The Commission has issued the enclosed Amendments Nos. 109 and 47 to Facility Operating Licenses Nos. DPR-57 and NPF-5 for the Edwin I. Hatch Nuclear Plant, Units Nos. 1 and 2. The amendments consist of changes to the Technical Specifications (TSs) in response to your applications dated July 9, 1982, October 24 and December 20, 1983, and April 24, 1984.

The amendments revise the Technical Specifications to reflect corporate and plant staff reorganization to change the composition of the Plant Review Board, to delete the Senior Reactor Operator license requirement for the Plant Manager, to change the level of approval for plant procedures, and to clarify procedures for review by the Plant Review Board.

Edwin I. Hatch Nuclear Plant,  
Units Nos. 1 and 2

GEORGIA POWER COMPANY  
OGLETHORPE POWER CORPORATION  
MUNICIPAL ELECTRIC AUTHORITY OF GEORGIA  
CITY OF DALTON, GEORGIA  
DOCKET NO. 50-321  
EDWIN I. HATCH NUCLEAR PLANT, UNIT NO. 1  
AMENDMENT TO FACILITY OPERATING LICENSE

FIGURE 6.2.2-1 UNIT ORGANIZATION

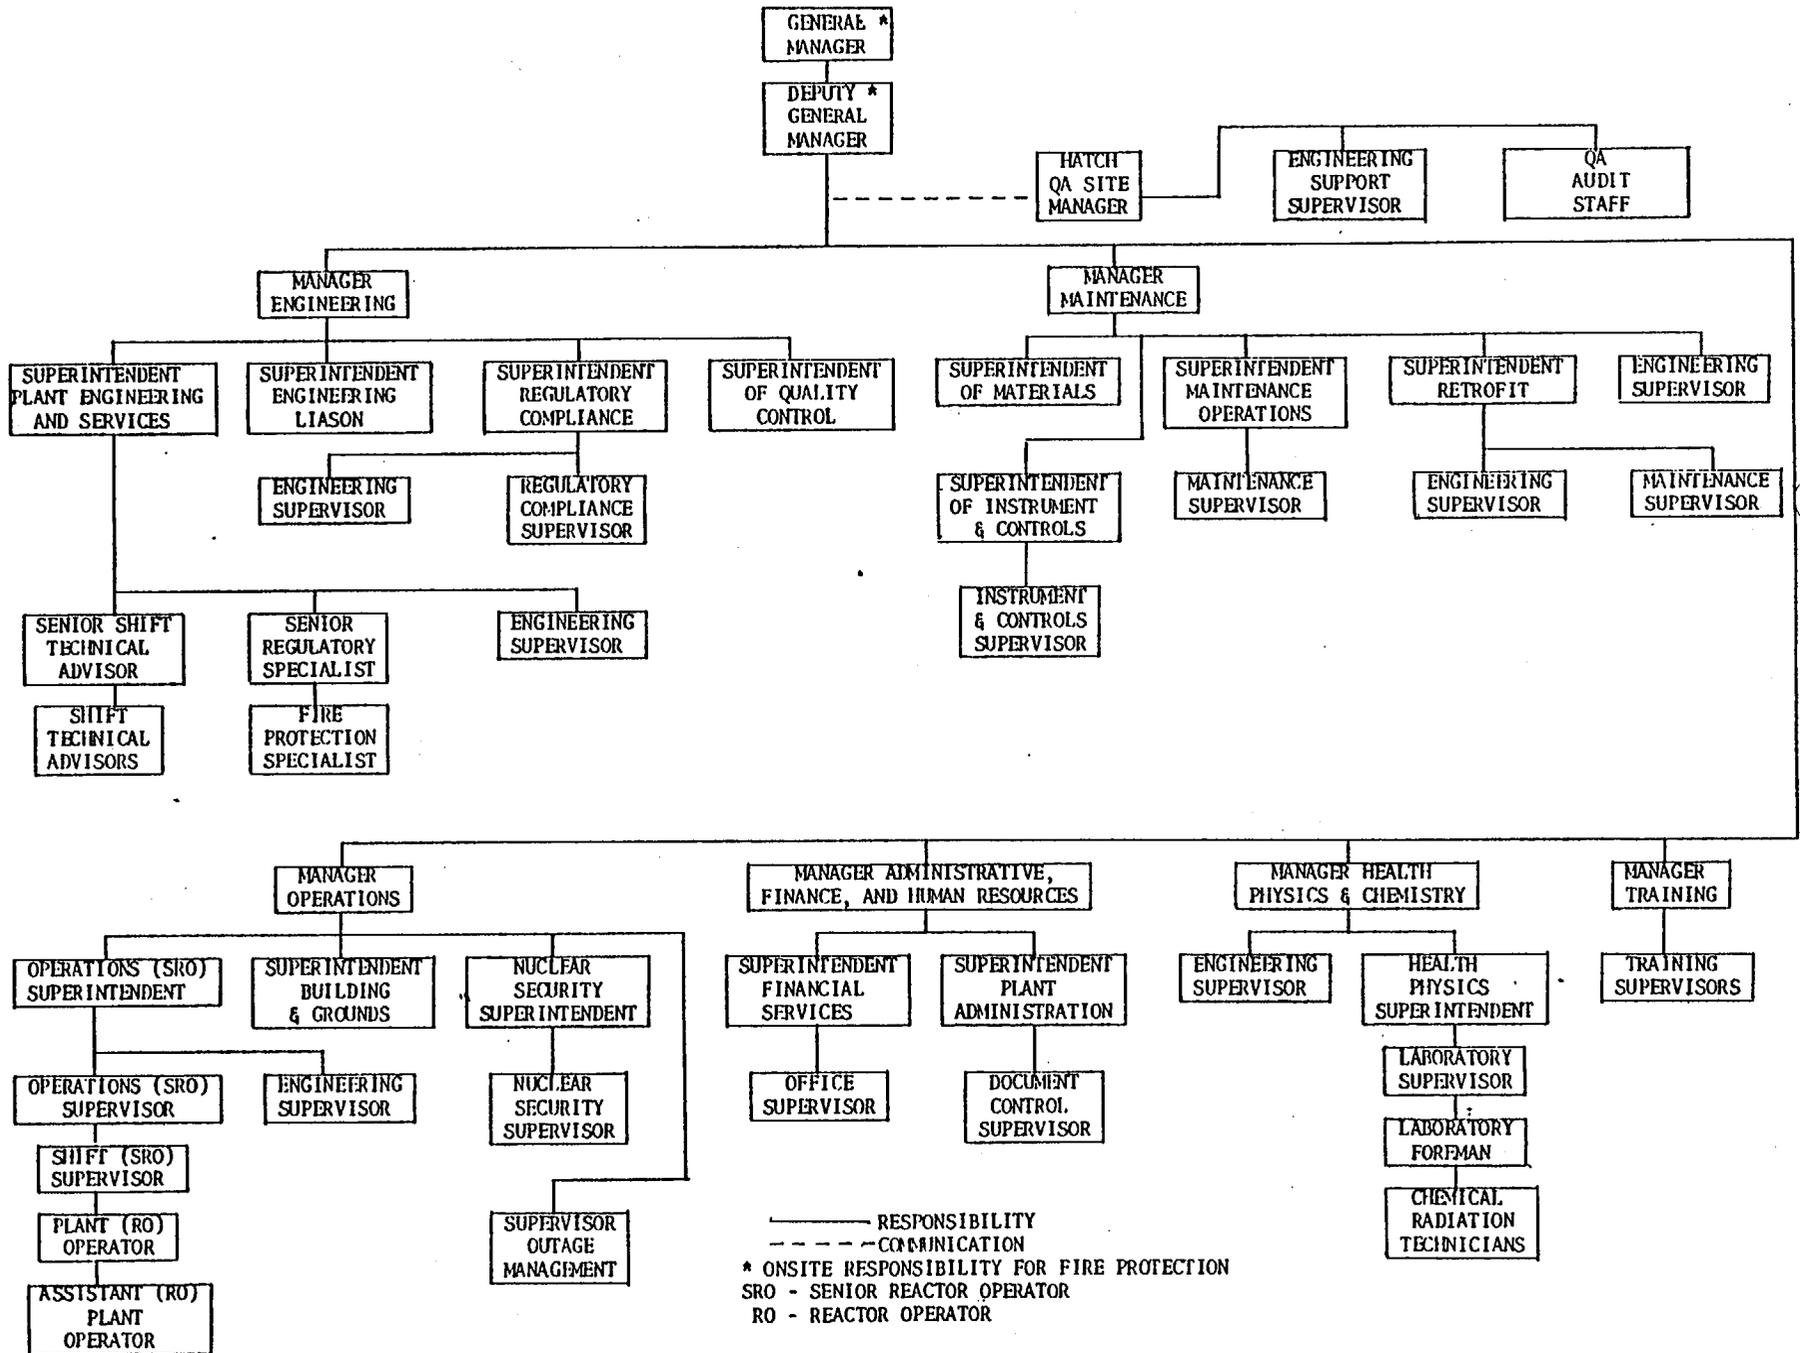
2. Plant staff reorganization - The positions of Plant Manager and Assistant Plant Manager have been retitled to General Manager and Deputy General Manager respectively. Reporting to the Deputy General Manager is a new level of Managers: a Manager-Engineering; Manager-Maintenance; Manager-Operations; Manager-Administrative, Finance, and Human Resources; Manager-Health Physics and Chemistry; and a Manager-Training, with their respective staffs. This is shown in revised Figure 6.2.2-1. The revised plant staff has deleted the requirement that the General Manager (formerly Plant Manager) or the Deputy General Manager (formerly Assistant Plant Manager) have a Senior Operators License.

We have reviewed these changes and find that they do not delete technical support for the operation of the Hatch Station and meet the acceptance criteria of Section 13.1.2 of the SRP (NUREG-0800). Therefore, we find these changes acceptable.

FIGURE 6.2.1-1 OFFSITE ORGANIZATION

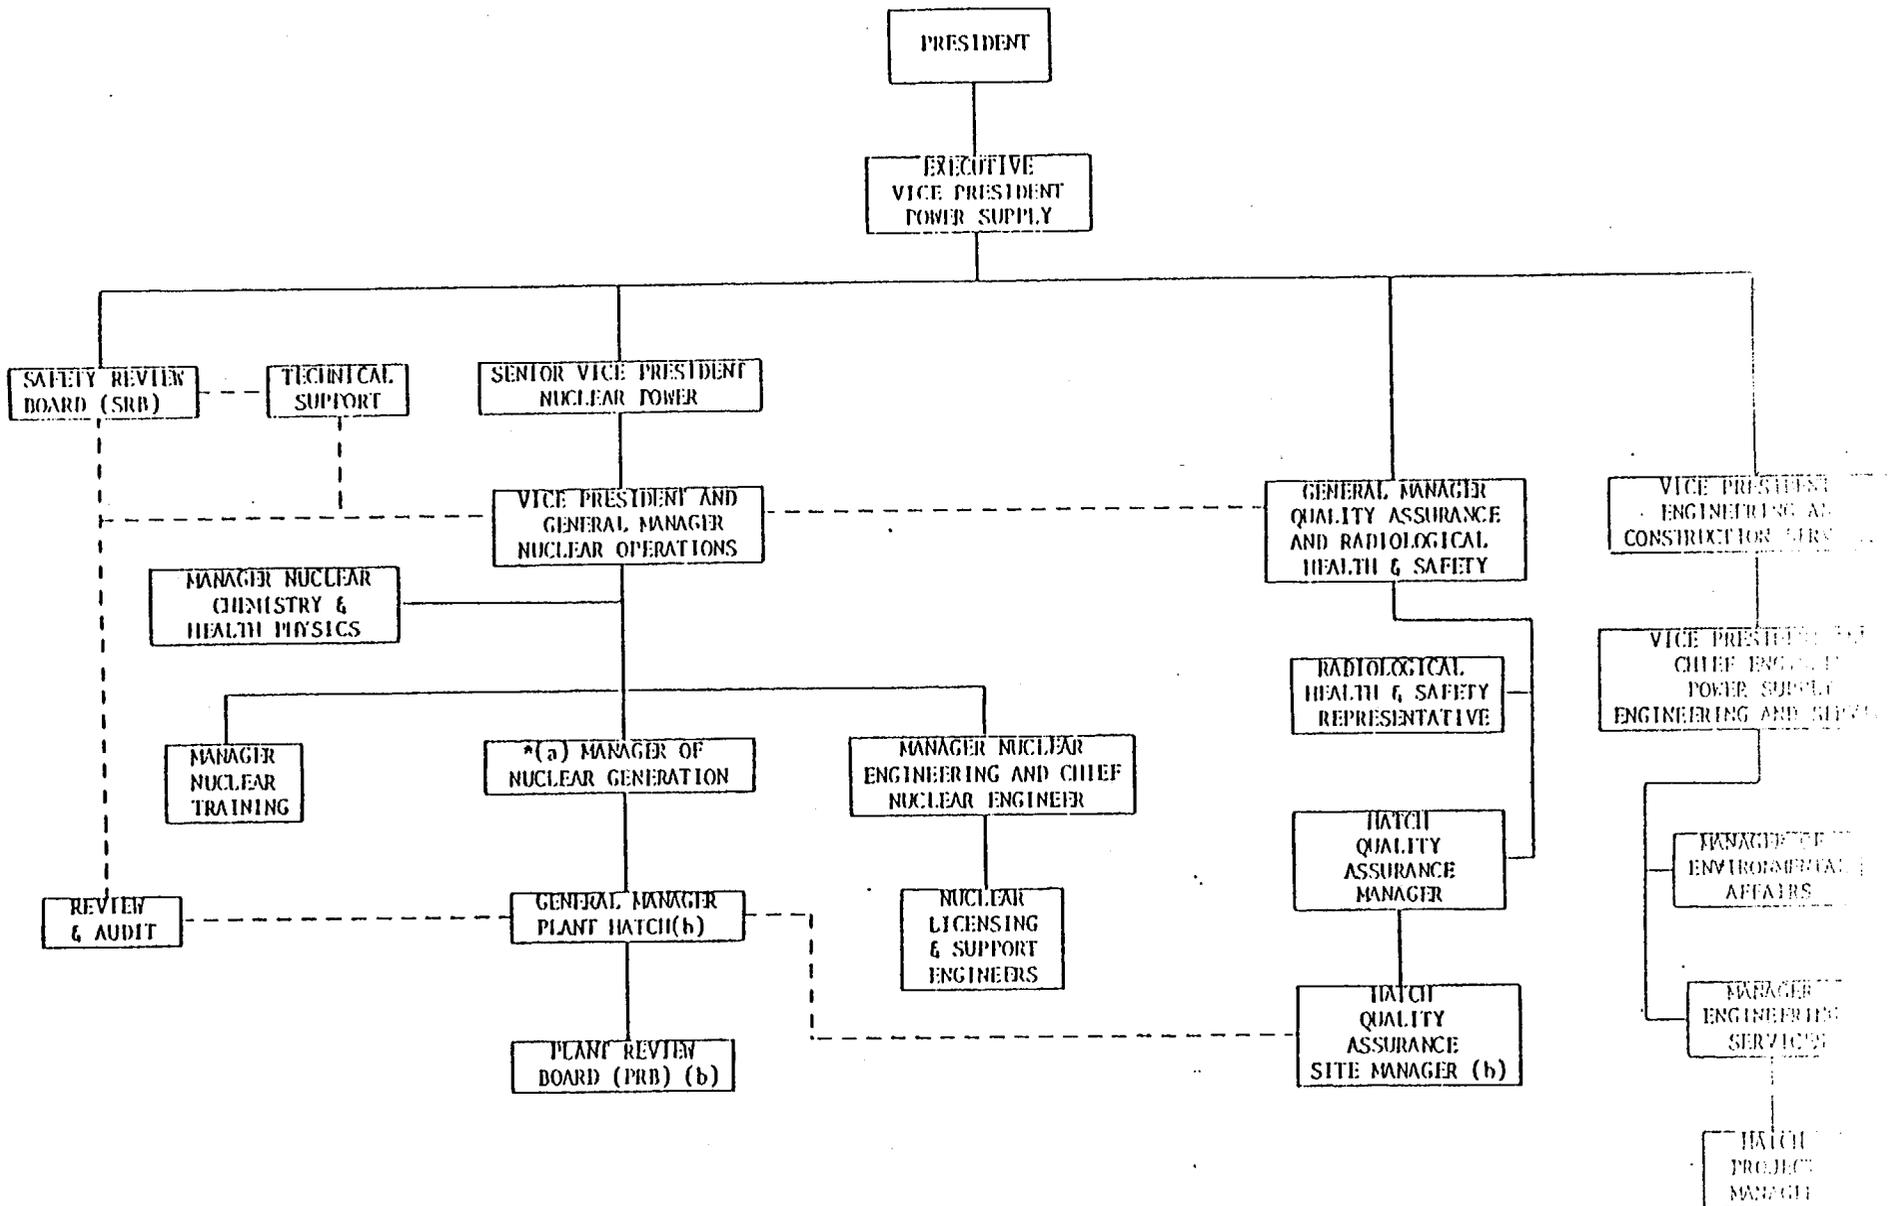
1. Corporate Reorganization - The licensee has established under the Executive Vice President-Power Supply, a Senior Vice President-Nuclear Power who will be responsible for all Georgia Power Company (GPC) nuclear generating plants. Reporting to the Senior Vice President-Nuclear Power will be a Vice President and General Manager-Nuclear Operations who has reporting to him a Manager-Nuclear Chemistry and Health Physics, a Manager-Nuclear Training, a Manager-Nuclear Generation, and a Manager-Nuclear Engineering and Chief Nuclear Engineer.

Reporting to the Executive Vice President-Power Supply is a General Manager-Quality Assurance and Radiological Health and Safety who establishes GPC policy and programs in these areas. The Vice President-Engineering and Construction Services, who also reports to the Executive Vice President-Power Supply, provides engineering support for plant additions or modifications. The Safety Review Board also reports to the Executive Vice President-Power Supply. Technical support for the Hatch Station is still supplied by the Southern Company Service in engineering disciplines and for the nuclear fuel.

This organization structure is shown in a revised Figure 6.2.1-1.

We have reviewed these changes and find that they do not delete technical support for the operation of the Hatch Station and should provide for increased upper level management involvement in support of the Hatch Station. These changes also meet the acceptance criteria of Section 13.1.1 of the SRP (NUREG-0800). Therefore, we find these changes acceptable.
